**Statement of Response to An Bord Pleanála's Opinion
in relation to Reg. Ref.: ABP- 311666-21**

A Proposed Strategic Housing Development

**The Former ABB Site, Belgard Road,
Tallaght, Dublin 24.**

John Spain Associates

Overview of key changes at ground floor level. (Source: CWOB, 2022).

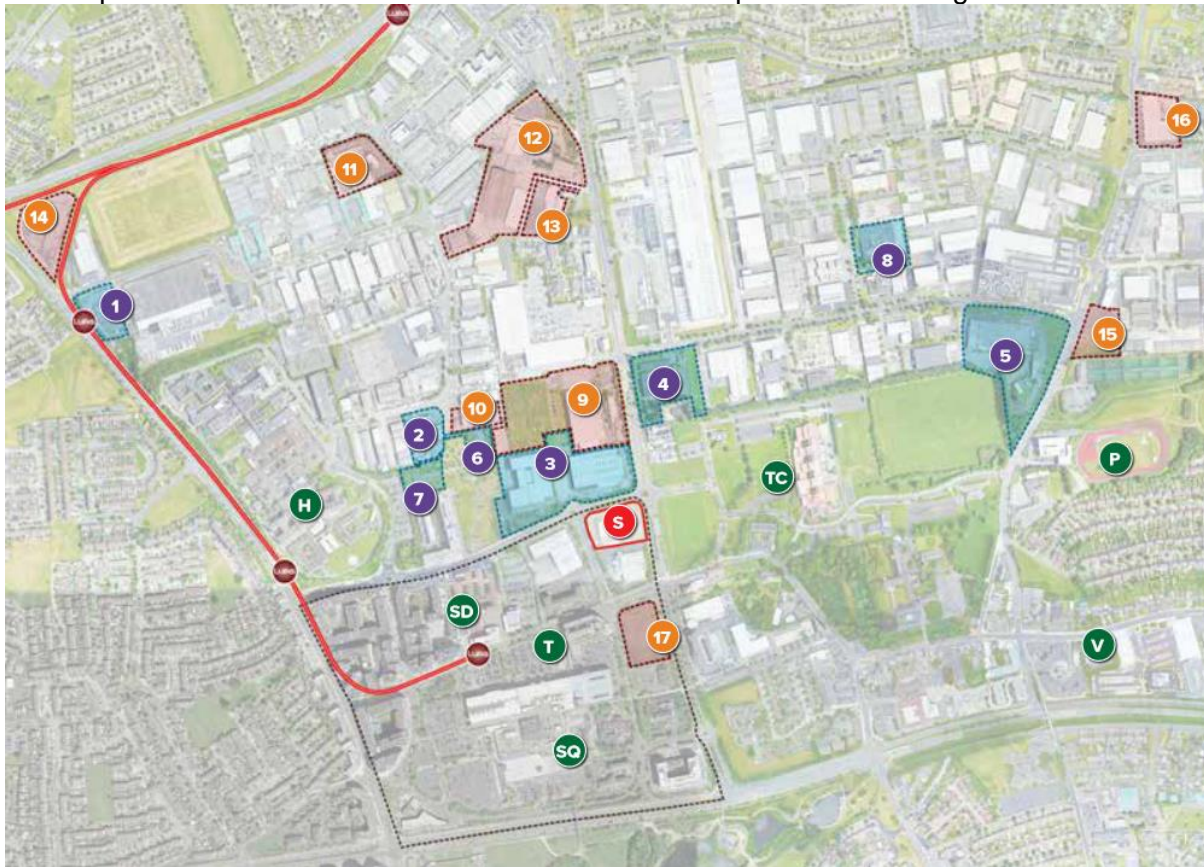
2.9. In addition, the development has also been revised in regard to the other aspects of Issue 1 notably ground floor uses, these key changes can be summarised as follows:

- A review of the uses on the ground floor resulted in the movement of the commercial spaces to the western side of the development with the BTR amenity space along the northern façade.
- Review of the open space with an increase in space provided on the southern boundary. This was achieved by pulling back the podium between Blocks A & B and creating a large public square. Review of the landscape strategy for the public realm.

“As stated, the commercial uses proposed within the scheme have been relocated to the western edge of the development, providing a fine urban grain and encouraging an active mix of uses, business types and unit frontages at this location. The northern edge of the development facing onto Belgard Square North hosts the majority of the BTR amenity spaces which engage with the street and are supported by the pocket parks which form a critical part of the public realm. Please refer to Sections 7.0 Layout, 10.0 Privacy + Amenities and 12.0 Detail Design of this document for an outline of the proposed features and layout for the active uses within the proposed scheme.

The reconfiguring of the ground floor to align more closely with the vision of the LAP also supports the visual and functional connection to the rest of the town centre. The review and increase of public open space along the southern boundary connection improves upon the permeability of the site and integration with the existing street network. These changes, in conjunction with further progression of the architectural and landscape proposals serve to contribute to and enhance the character of the wider area. Please refer to the detailed landscaping strategy that has been prepared by Cameo & Partners Landscape Architects and submitted as part of this application for further details on the landscaping strategy.”

View of proposed development from the north and east. (Source: CWOB, 2022)

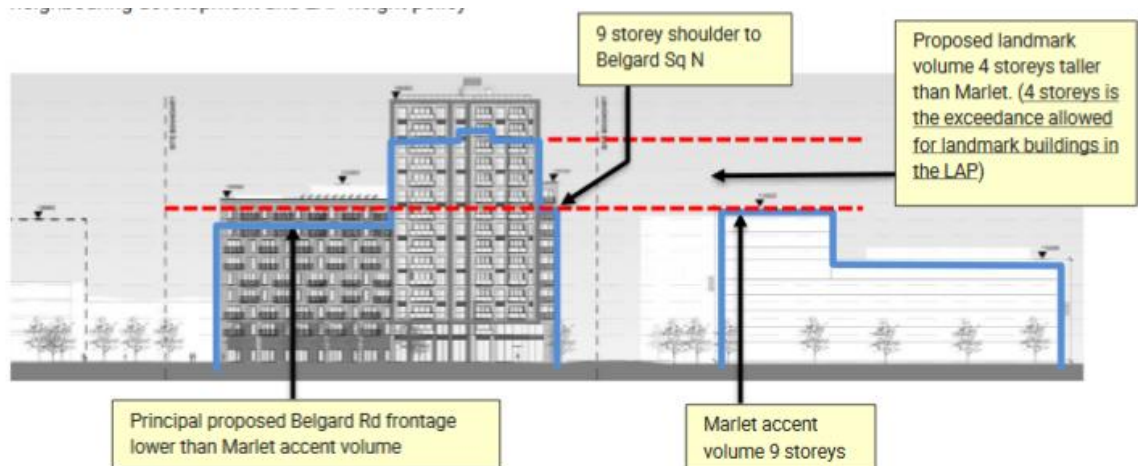
- iv. **Interface along the Site Boundaries:** *As stated above the southern boundary of the site has been proposed as a new pedestrian connection and public open space that provides a new tertiary route within the network of Tallaght Town Centre. Responding to comments from ABP and SDCC, the western edge of the scheme is populated by the commercial uses within the development. These uses will activate the street frontage along this boundary and support the already existing commercial core of the town. The amenity spaces are organised along the northern*

edge of the development and face out onto two proposed pocket parks. The interaction between these communal amenity spaces and the public open space of the parks will foster a sense of community and connection for residents and visitors alike. Finally, the eastern edge has a primarily residential function with a number of duplex and workspace units fronting out the street.

Hardscape strategy. (Source: Cameo, 2022).

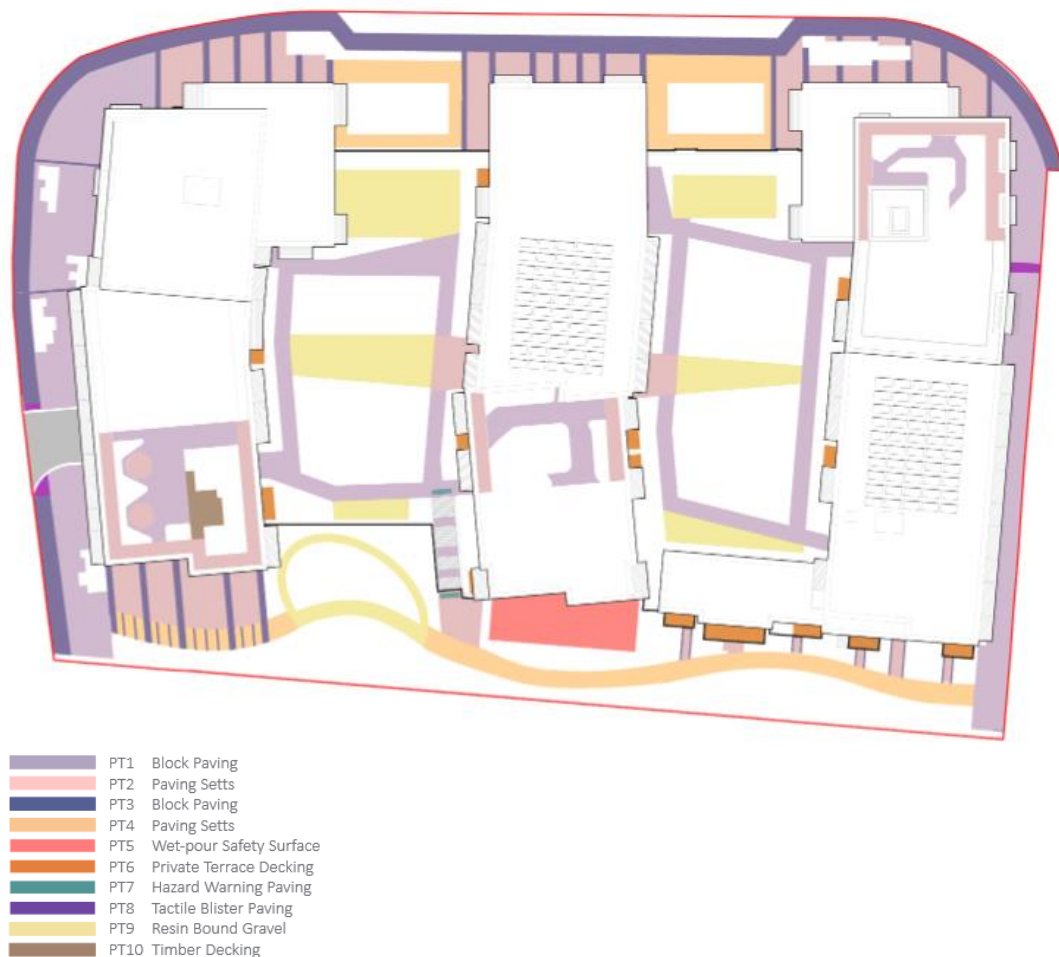
6. Detailed landscape drawings that illustrate hard and soft landscaping, useable communal open space, meaningful public open space, quality audit and way finding. The public open space shall be usable space, accessible and overlooked to provide a degree of natural supervision. Details of play equipment, street furniture including public lighting and boundary treatments should be submitted.

- 3.30. The hard landscape elements had been carefully selected to enhance the space. High quality elements will help to create a positive, inclusive and inspiring environment, where people feel comfortable to walk through, sit, contemplate and enjoy the landscape setting.
